CONVAIR

COMMERCIAL CHANGE PROPOSAL

SPEC NO.: ZD-22-003

MODEL: (880) 22-2

Enclosure: (A) One copy of sketch - GASEOUS OXYGEN SYSTEM
(for preliminary use only, Figure 3.19-4 will
be revised to reflect the above change)

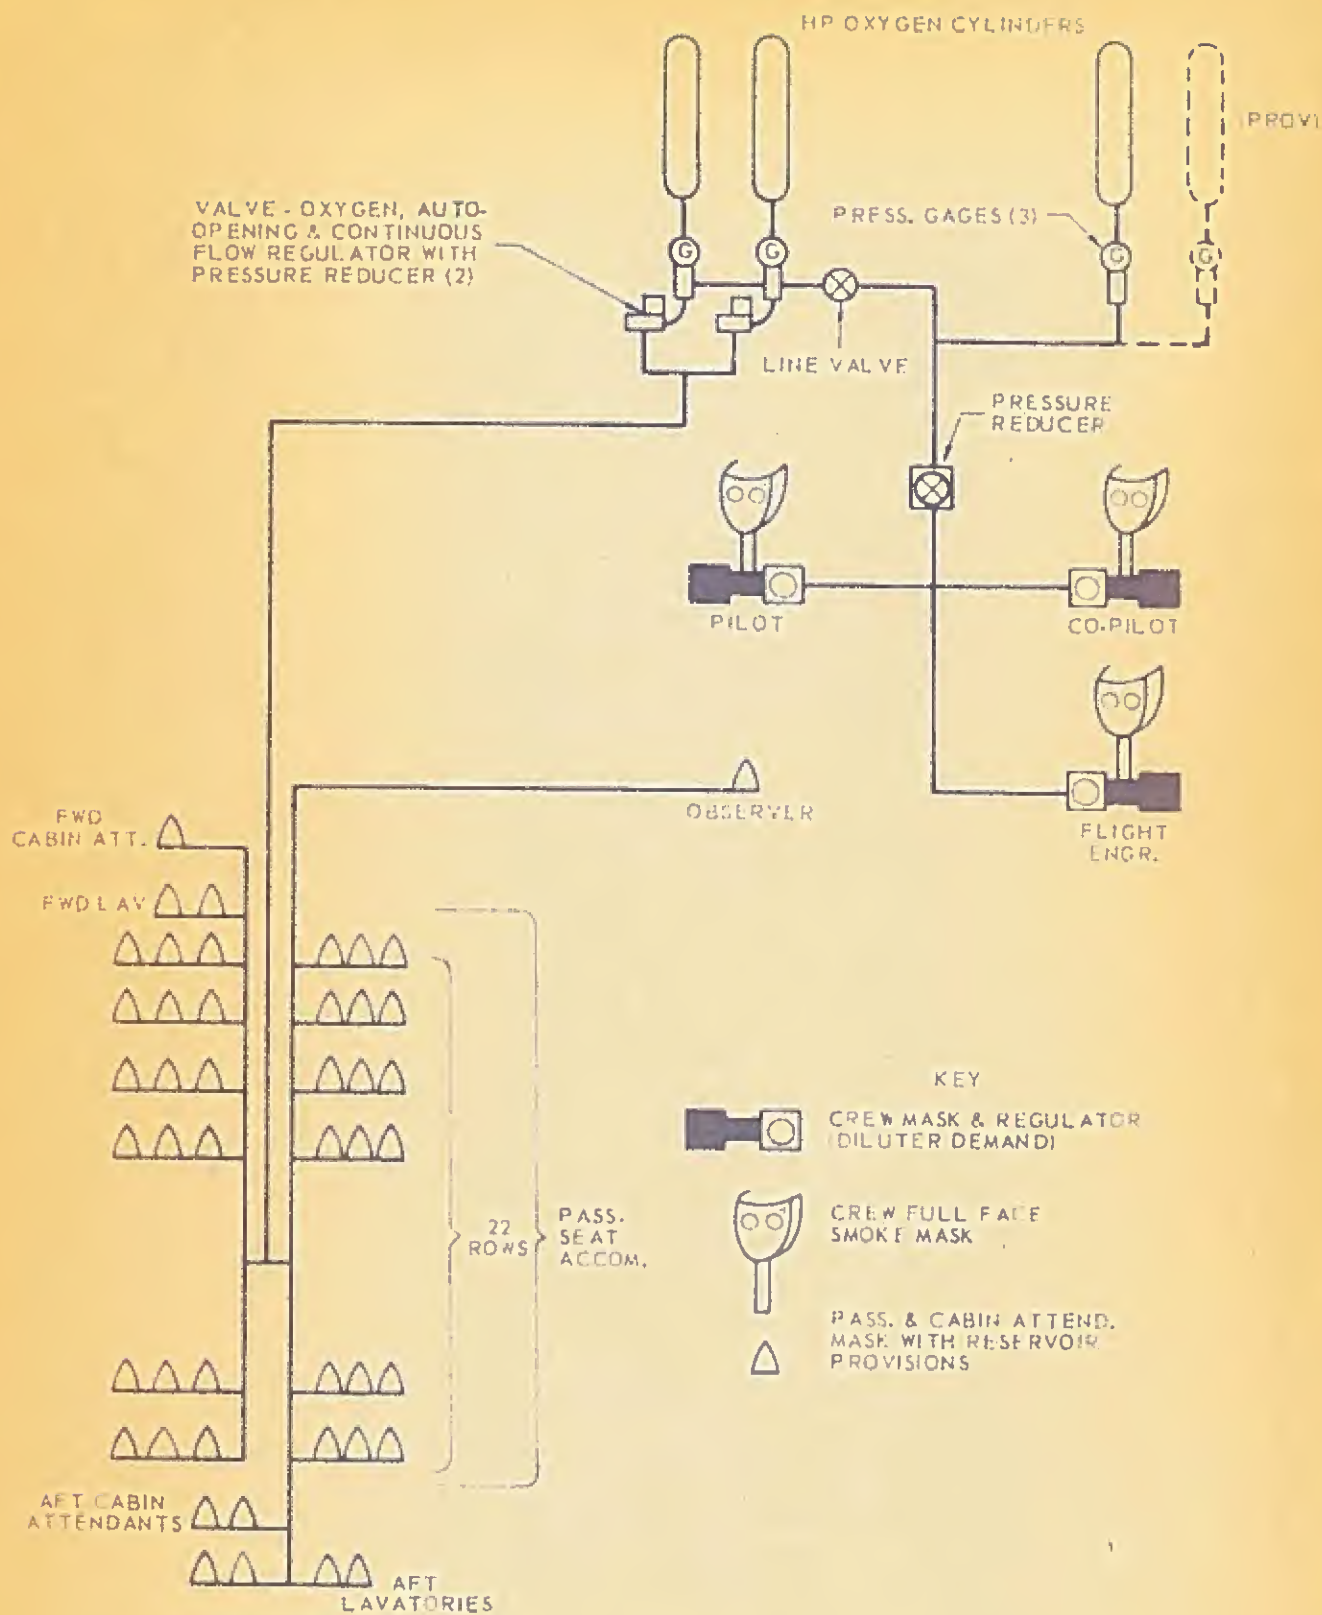
Page 114, Paragraph 3.19.5.5 MASKS:

Delete the following sentence from the paragraph:

"One oxygen outlet shall be provided in each lavatory."

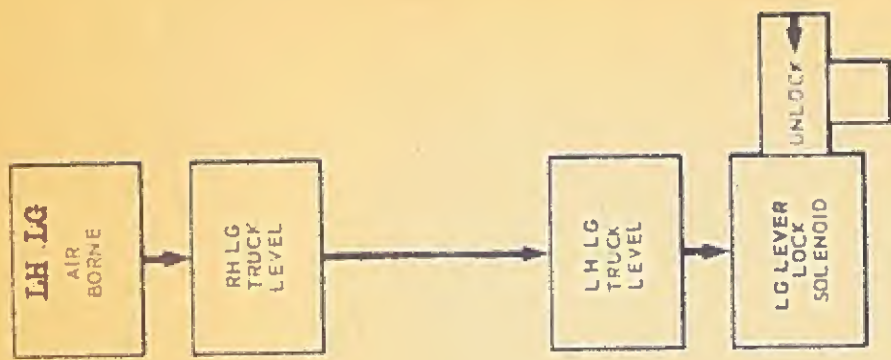
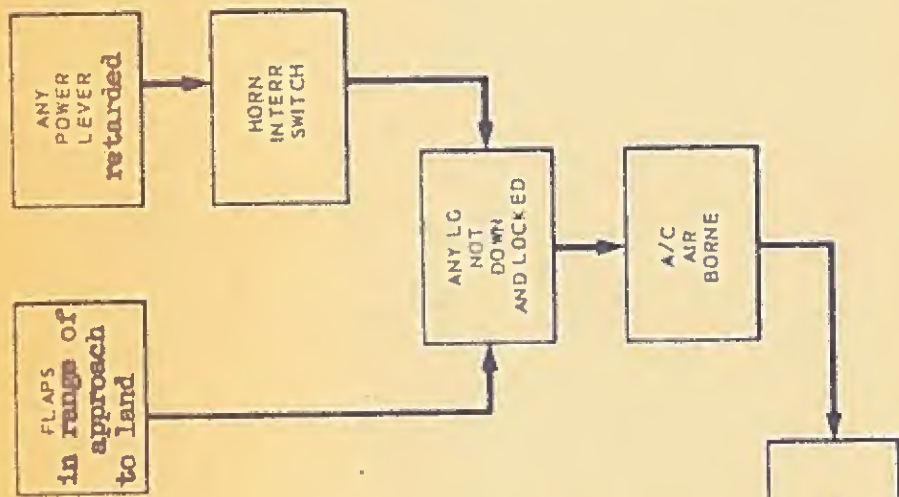
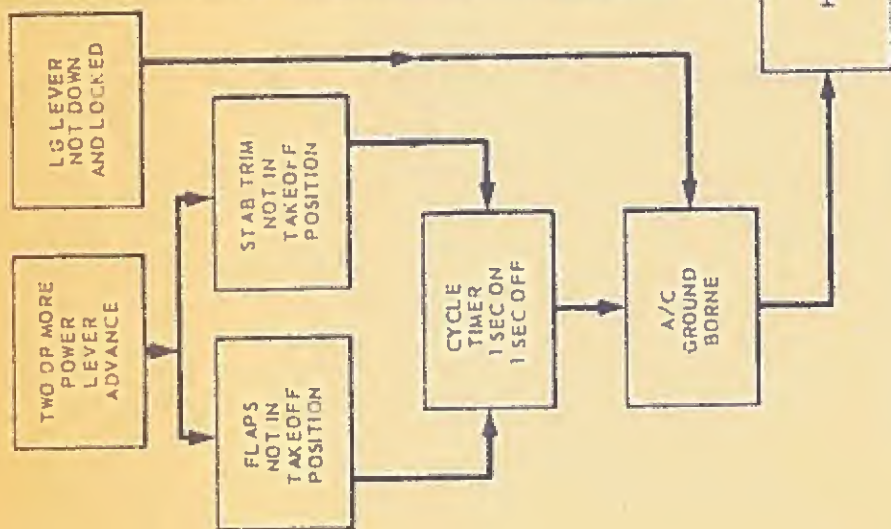
Revise the paragraph title and paragraph to read as follows:

"LANDING GEAR AND STABILIZER WARNING HORN: A horn shall be provided
to operate under the following conditions:

When any landing gear is not fully extended and locked with the air-
craft airborne, the horn will operate if any power lever is retarded
or if the flaps are in the range of approach to land. The power lever
retard function will have a horn interrupter switch.

When the aircraft is ground borne, the horn will operate if the landing
gear override lever is moved.

When the airplane is on the ground and any two or more of the power
levers are advanced to take-off position, the horn will operate if
the stabilizer and/or the flaps are not in the correct take-off posi-
tion."

C.G. & M.A.C.
C.G. DESIGN LIMITS

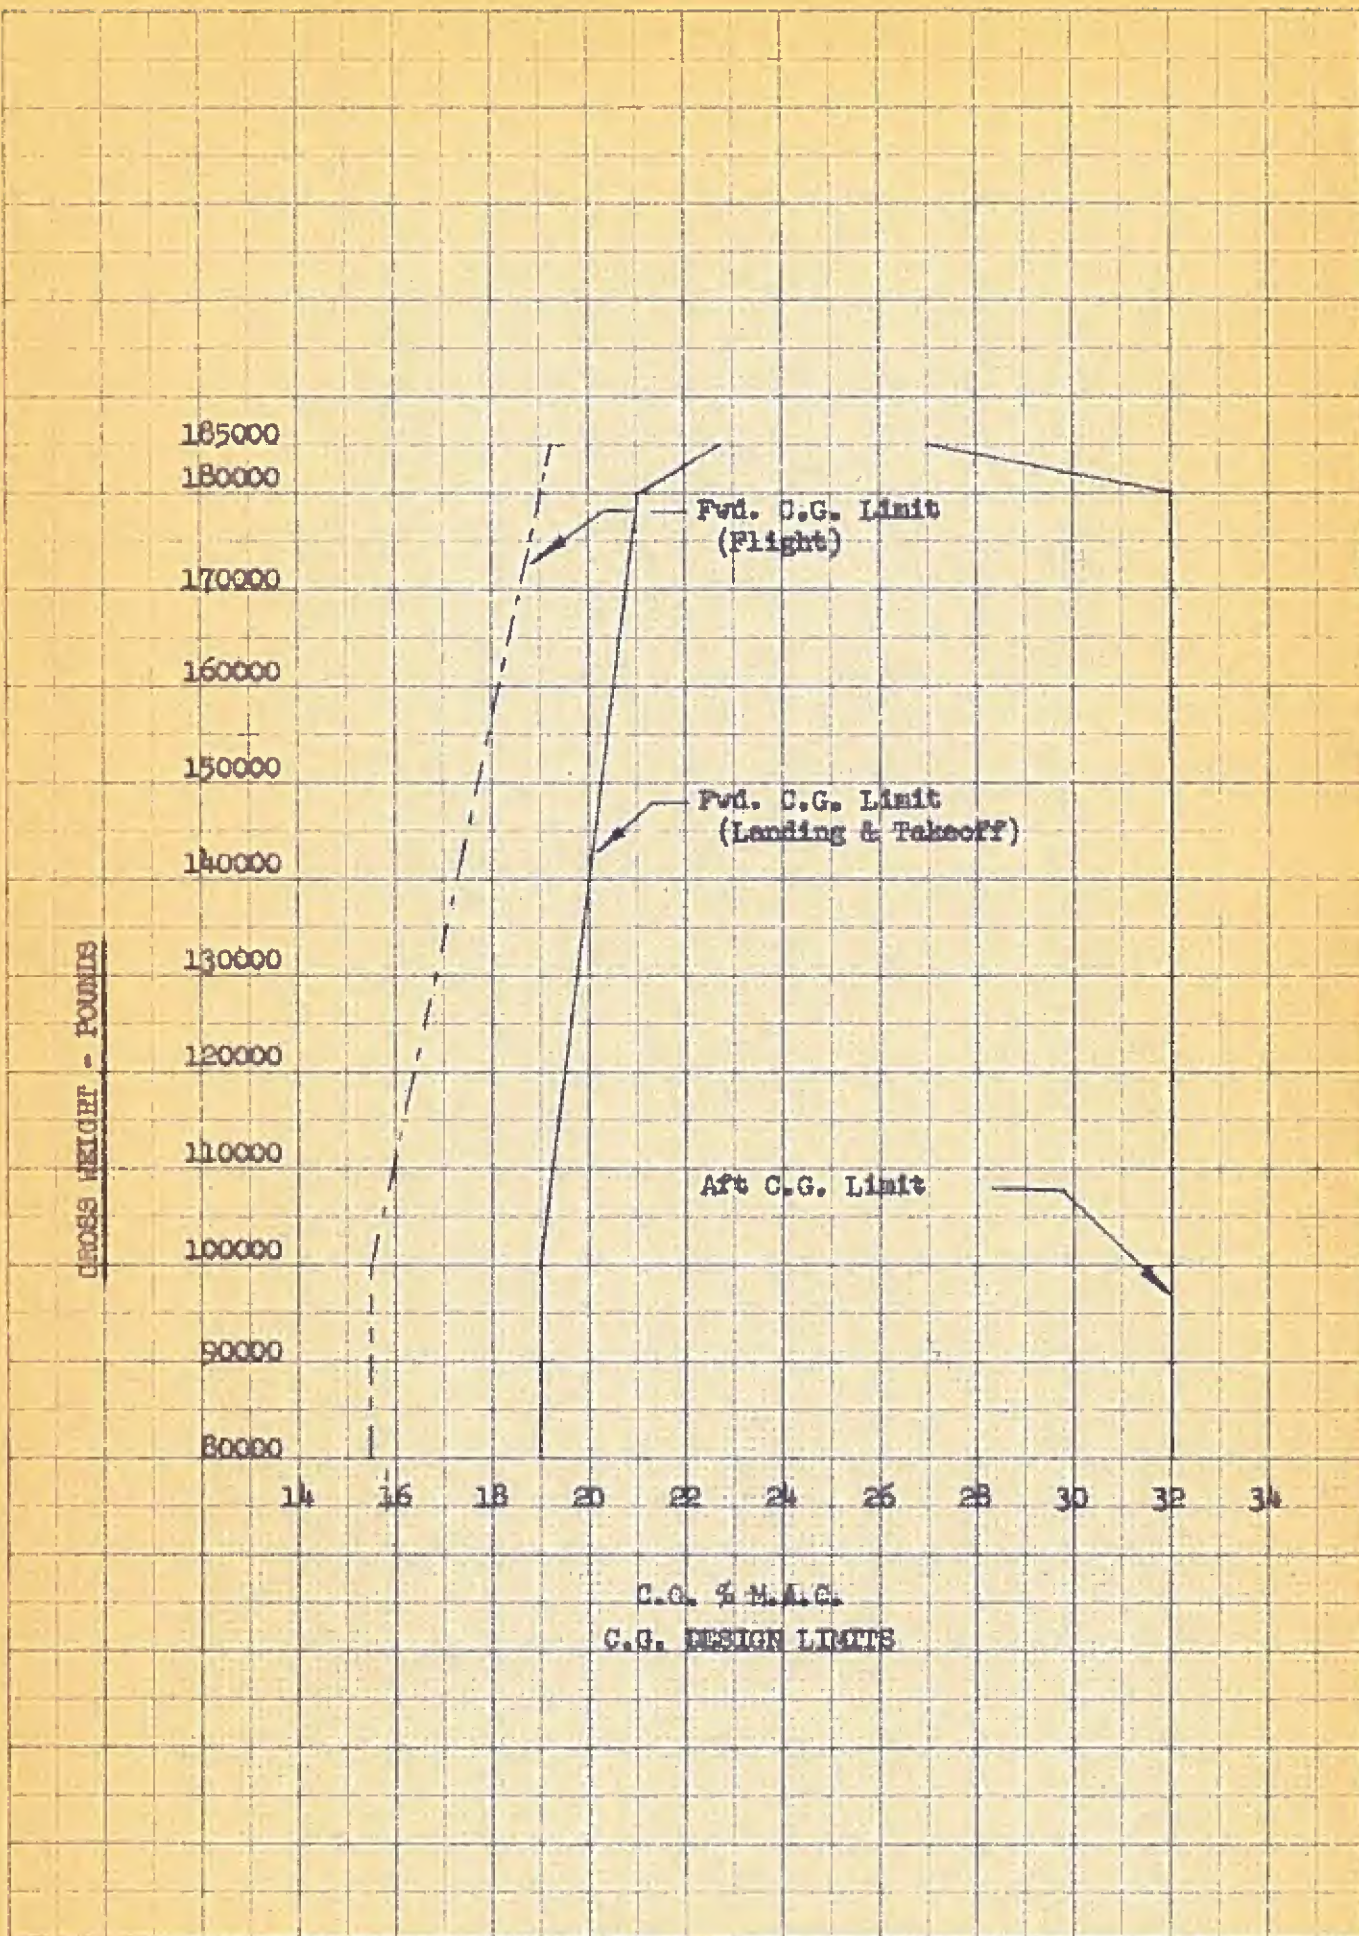
"Weight increase of 84 lbs is based on C.G. Limits shown on Enclosure (A). If the airplane is operated at gross weight above 180,000 lbs, with center of gravity locations outside of the indicated limits, heavier tires and main landing gears will be required."
